transmittal

project Kern Fan Groundwater Storage Project
Final Environmental Impact Report (EIR)

Final Environmental Impact Report
State Clearinghouse #2020049019

Prepared for
Groundwater Banking Joint Powers Authority:
Rosedale-Rio Bravo Water Storage District
and
Irvine Ranch Water District

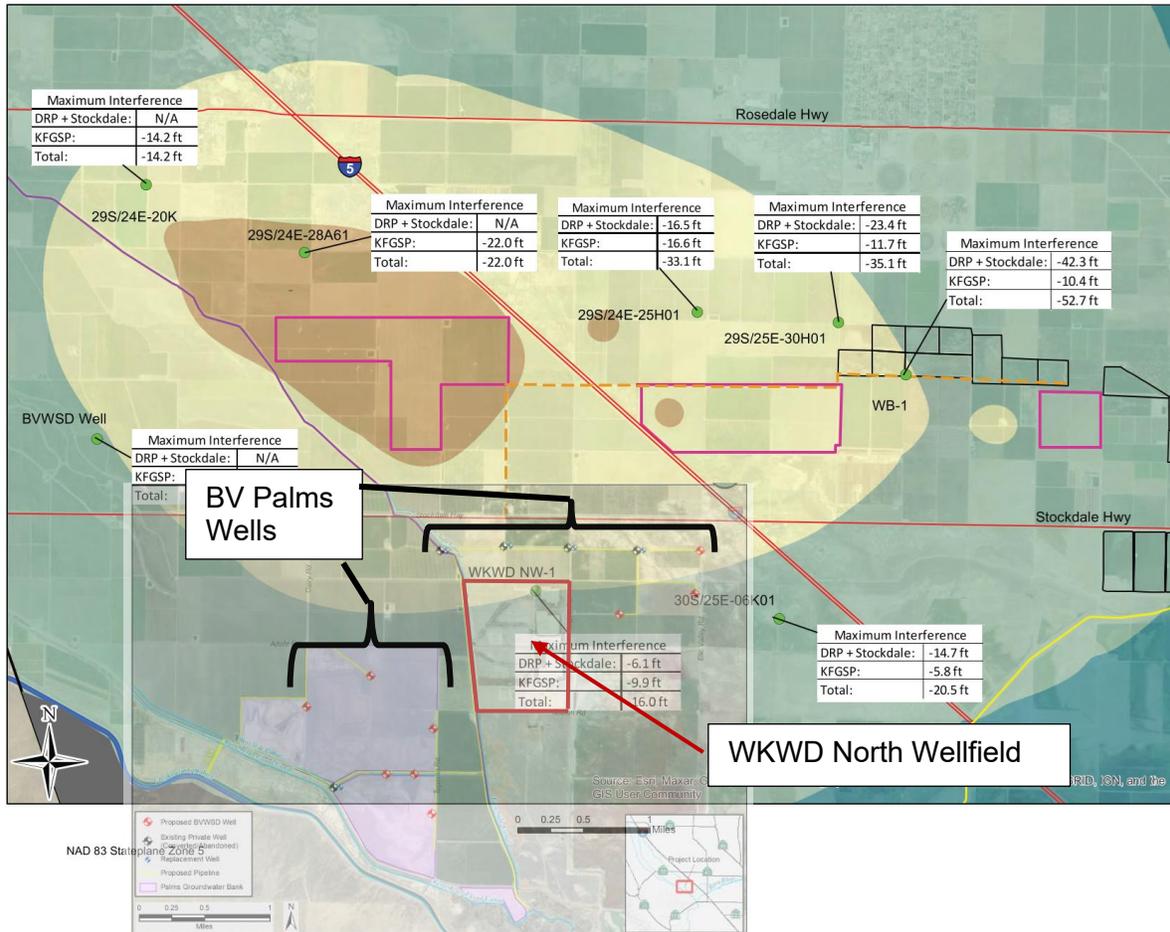
Provided on the next page is an overlay drawing prepared using figures from both the subject Kern Fan Groundwater Storage Project and the BV Palms project. The drawing illustrates the fact that a number of BV Palms extractions wells lie between the WKWD North Wellfield and the Kern Fan Groundwater Storage Project. If extraction is occurring in the BV Palms project at the same time extractions are occurring at the Kern Fan Groundwater Storage Project, at the Drought Relief Project (DRP) and at Stockdale the Integrated Banking Project, the impacts to WKWD North Wellfield wells could be greater than anticipated by the modeling.

An additional concern is that without clear direction in the DEIR in the case of a cumulative impact on WKWD, mitigation of the issue may be drawn into a situation where the various entities that operate the four projects mentioned above may not agree on the cause of the impact on WKWD, and this may inhibit timely mitigation response(s)

Kern Fan Groundwater Storage Project
Figure 2-1 Revised
 Regional Project Location

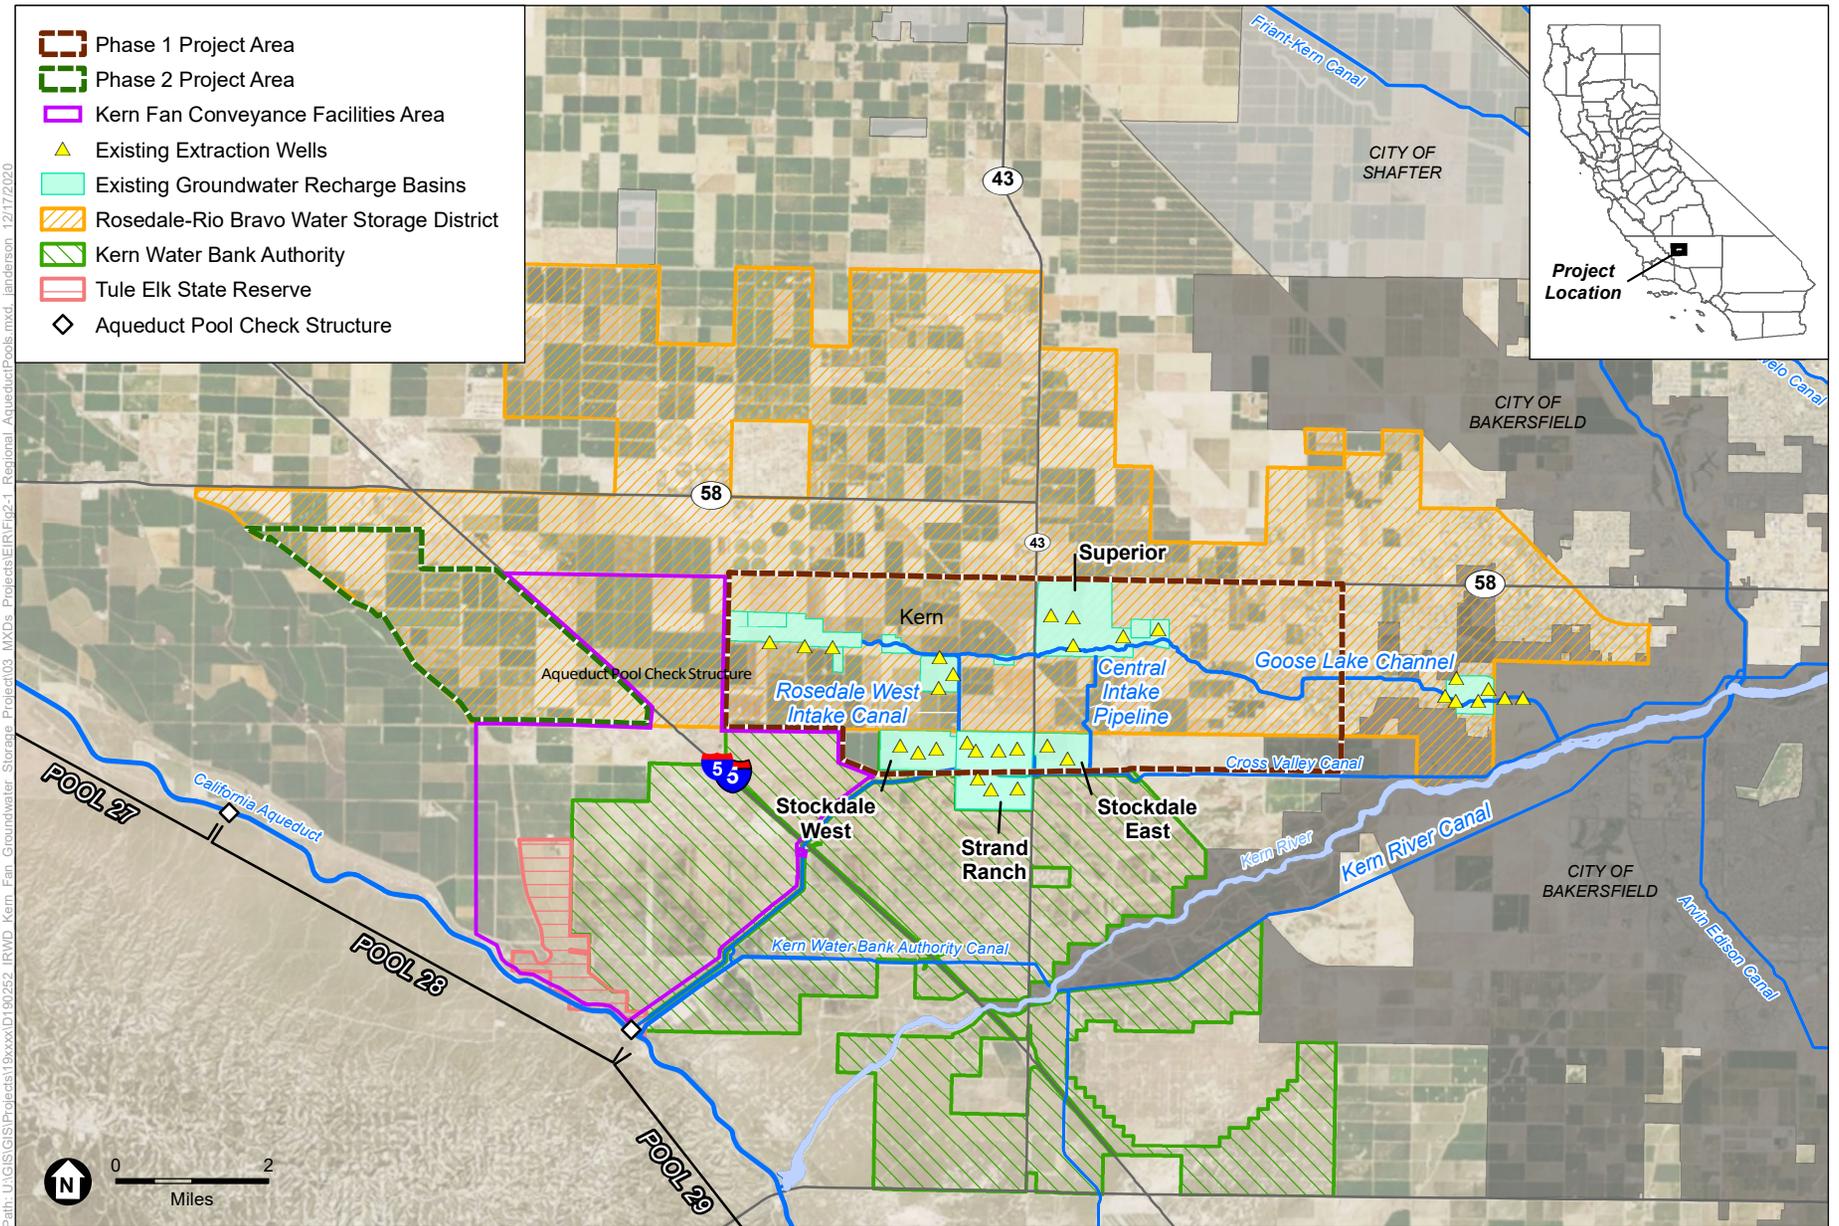
DWR – 6

The comment states that the Draft EIR's Project Description includes insufficient information on construction of the turnout at the California Aqueduct. The comment then states that the construction schedule does not consider potential impacts of ongoing or simultaneous construction activities in the vicinity involving the maintenance of the Aqueduct. The comment states that the Draft EIR does not provide a reasonably specific location of where the turnout would be placed, nor does the analysis of construction activities adequately address potential impacts to the Aqueduct and other SWP facilities.

In addition, in response to the comment, Figure 2-1 of the Draft EIR is revised to show the location of Pool 28 of the California Aqueduct, which is directly adjacent to the area identified for the Kern Fan Conveyance Facilities, of which the proposed turnout would be a component.
